710 N. Estes

Applicant drawings dated 4-13-22

Summary of Design Review Process and Outcomes

Prepared by: Brian Peterson, AIA, Urban Designer, TOCH

Sketch 1

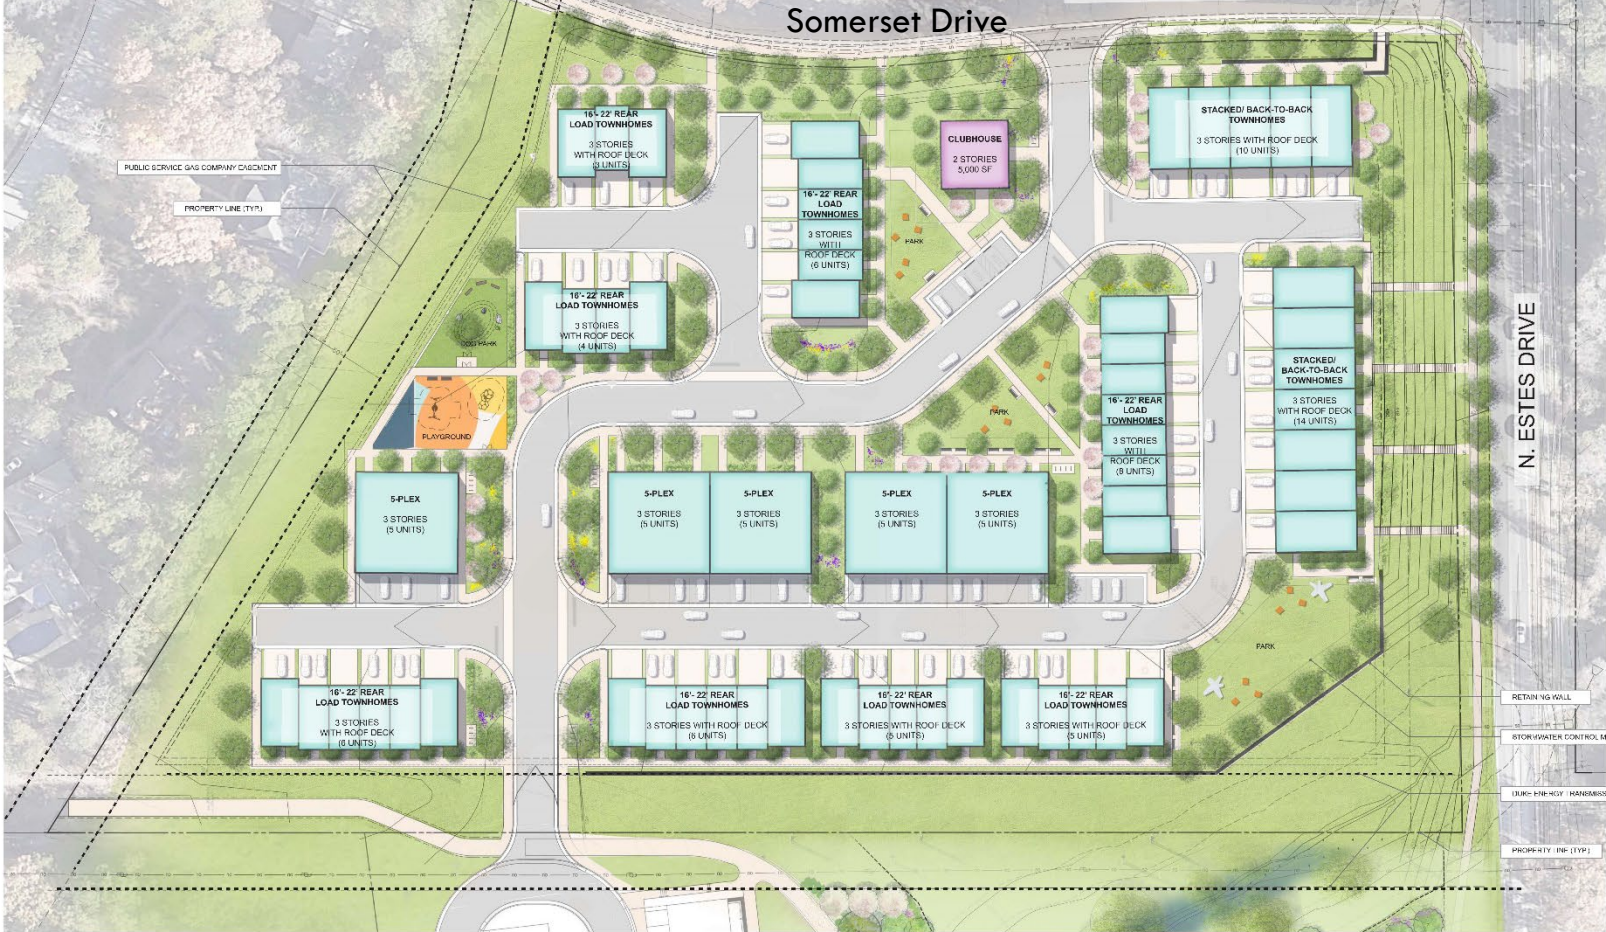
A design review meeting was held with the applicant earlier in the year, to discuss the site plan dated 12-28-21 (see attached sketch 1). For that meeting I prepared a concept sketch with suggested revisions (see attached sketch 2). The suggested changes in that sketch can be summarized as follows:
